Subject: TMI Unit 1 Response to NRC Request for Additional Information Regarding Relief Requests (RR-00-01 Through RR-00-13) Associated with the Third Ten Year Inservice Inspection (ISI) Interval Program Plan

AmerGen Response to NRC Request for Additional Information Regarding Relief Requests submitted with the Third Ten Year ISI Interval ISI Program Plan

Figure 1 - Letdown Cooler Internals

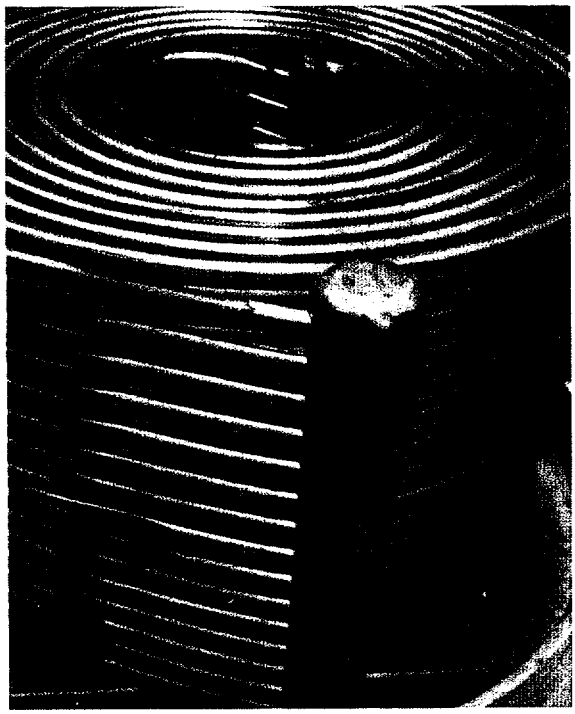
NRC Request:
For the letdown coolers longitudinal welds, the Code requires the examination of 1 foot of longitudinal weld intersecting the circumferential weld?

What is the appropriate length of a longitudinal weld that the licensee is able to examine? Why can't the licensee examine additional longitudinal welds and/or both coolers?

Provide a drawing(s) showing welds and identify accessible areas. What percentage of the required 1 foot are you able to obtain on one cooler?

AmerGen Response:
Except for the straight portion of accessible manifold (approximately 1¼ inch length on the inlet side and approximately 2¾ inch on the outlet side) that will be examined, the balance of the longitudinal welds intersecting the circumferential weld is covered by the shell side of the heat exchanger. Additional longitudinal weld length is not accessible since it is totally enclosed within the Class 3 (heat sink) side of the vessel. Access to additional longitudinal weld length would require removal of fabrication welds and destruction of the unit. Table IWB-2500-1, Category B-B states that the examination may be limited to one vessel among the group of vessels performing a similar function.

As shown in Figure 1, the letdown coolers are counter flow, spiral tube heat exchangers that reduce the temperature of letdown flow to protect the demineralizer resins and the Reactor Coolant Pump seals. The secondary shell side is cooled by the Intermediate Closed Cooling Water (ICCW) System. Longitudinal welds run the full length of both sides of the two 3¾ inch outer diameter (OD) "cylinders" which comprise the primary inlet and outlet manifolds that connect to the tube ends of the (30) ¾ inch OD helical coils within the external casing shell. The secondary shell side has been fabricated around these components and only the inlet and outlet manifold stubs protruding from the cooler are accessible. Each manifold has two longitudinal seam welds and each letdown cooler has four such welds.

Figure 1 is a photograph of the Letdown Cooler internals (cooling coils and manifolds) with the casing removed for destructive examination. In this photograph the component is laying on its face with the accessible portion of the longitudinal welds on the underneath side and therefore not visible. Cooler leaks in 1978 and 1987 were found to have originated where the coils are tack welded to each other. Procedure changes to reduce the flow and the heat load by operating both coolers in parallel and to ramp the flow more slowly have resolved the problem and subsequent replacement has not been necessary.

The accessible approximately 1¼ inch length of the inlet manifold seam welds and approximately 2¾ inch of the outlet side manifold seam welds represent approximately 10.4% and 22.9% of the required 1-foot length of each weld. Examinations conducted for the first and second ISI intervals were essentially the same in accordance with relief granted by the NRC on March 20, 1987 (first interval) and October 8, 1992 (second interval). No unacceptable indications were identified. Although the first and second examination coverage was the same, the Code requirement applicable to the first interval only required 10% of each weld (3.1 inches vs. 12 inches). Therefore, for the first ISI interval the percentage of examination coverage was greater (40.3% and 88.7% of the required lengths of inlet and outlet manifold seam welds respectively) for the first interval examination compared to that of second interval examination and that planned for the third interval. The examinations planned
